Subject: Repair of the fender assembly

Bulletin Type: FC

Bulletin No: TS45-FC-2521

Vehicle Model: TS45

1. Assembly: RP150085-01Y FENDER MOUNTING FRONT LEFT & RIGHT.

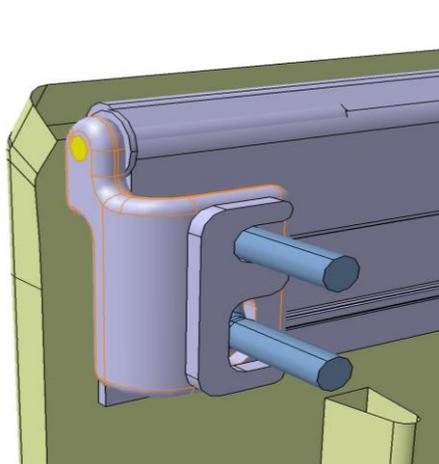
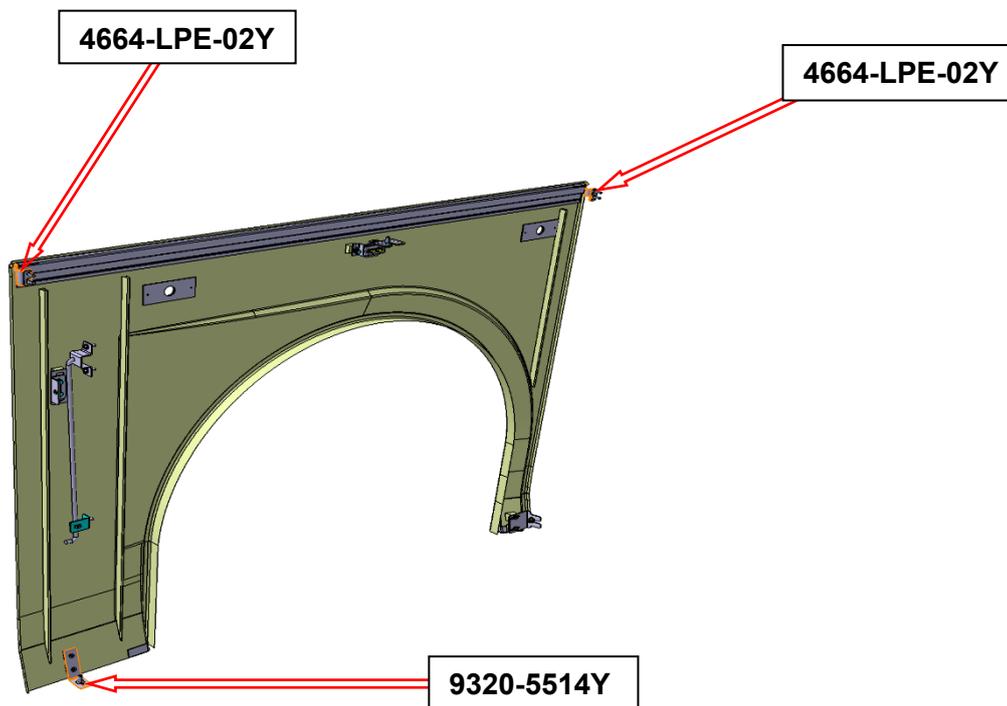
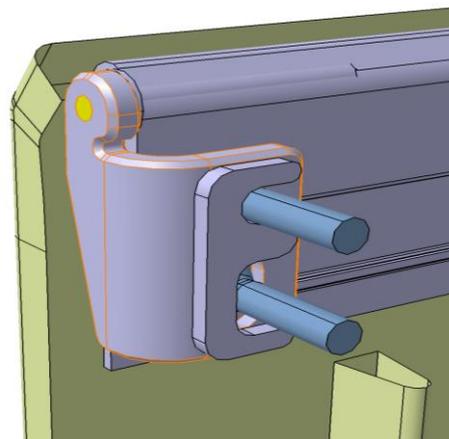
Hinges numbered **4664-LPE-02Y** and **4664-LPE-08Y** will be removed and the same coded, updated version parts will be installed.

2. Assembly: RP150085-01Y FENDER MOUNTING FRONT LEFT & RIGHT.

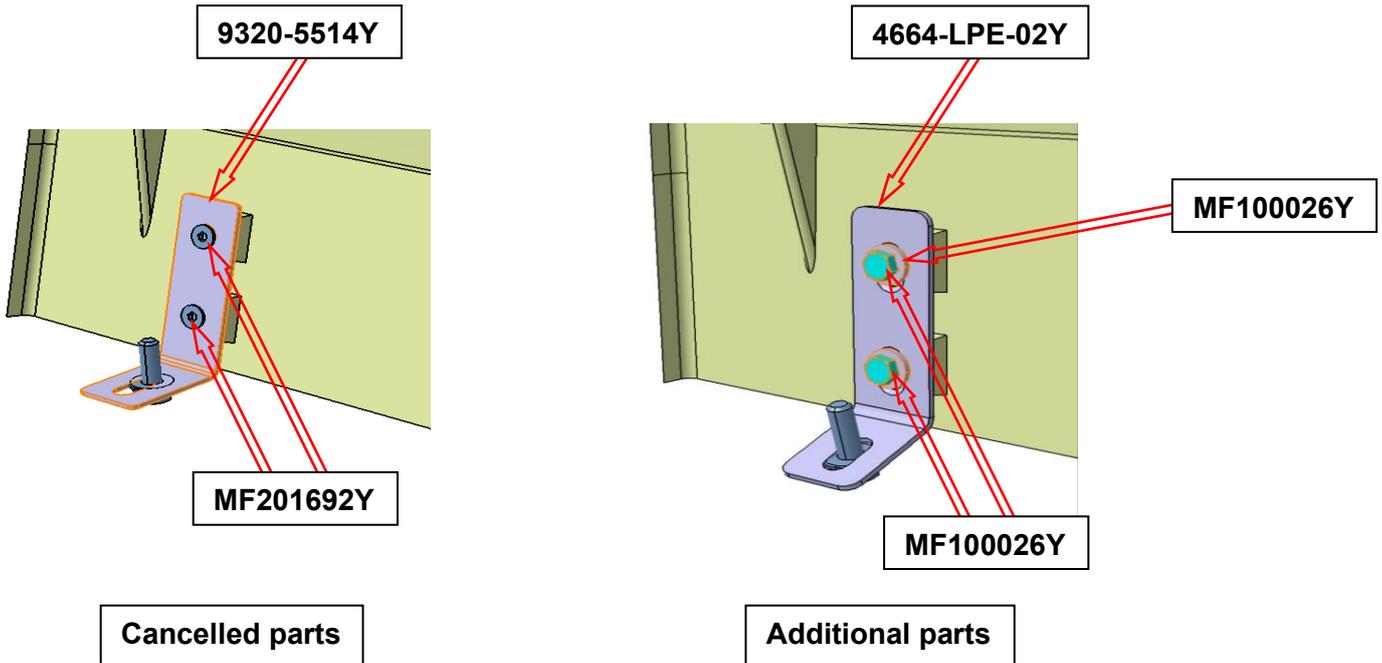
Bracket numbered **9320-5514Y** will be removed and bracket numbered **4664-LPE-02Y** will be installed in its place. Two AKB bolts numbered **MF100026Y** and a washer numbered **MF100026Y** will be used instead of two Allen-head bolts numbered **MF201692Y** used as mounting fasteners.
